**URGENT – FIELD SAFETY NOTICE**  
**FSCA IDENTIFIER SAN 02/10/MBD**  
**28<sup>TH</sup> JUNE 2010**

**Subject:** Manual CPR mechanism on some Huntleigh Contoura 880 hospital beds may fail to operate

**Products affected:** Huntleigh Healthcare Ltd Contoura 800 series beds produced between January 1999 and April 2001 inclusive, sold as:-

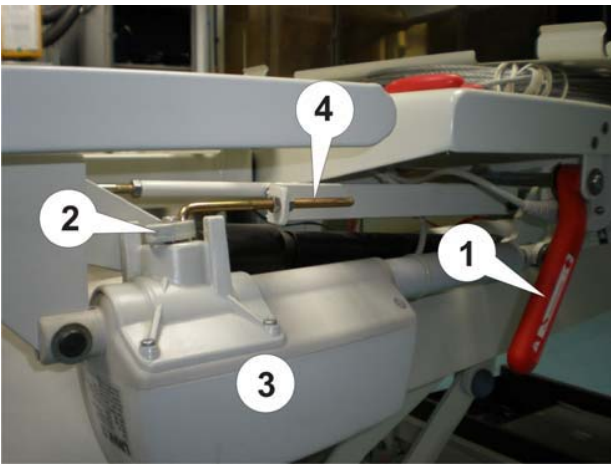
**Please also note that this notice only affects Contoura 800 series bed models fitted with folding three-quarter length side rails [A above]. Beds with split side rails [B] are not affected**

**Item 2**  
In this photo the corner of the release arm has been broken off

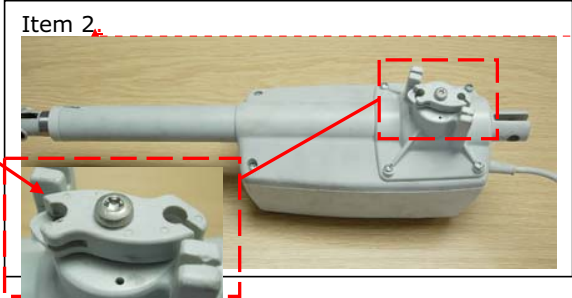
Beds made between January 1999 and April 2001 inclusive may suffer damage to their manual CPR mechanism if the CPR lever [1] has been pulled with excessive force. Damage may occur to the plastic release arm [2] fitted to the backrest actuator [3] or to the CPR adjustment pin [4].

A modification to the CPR design was introduced for beds manufactured after April 2001 and a retrofit kit, part number 806.399, has been developed which allows pre-April 2001 beds to be modified in line with the later specification. The later design prevents over travel of the CPR lever and thus prevents the mechanism from being damaged.
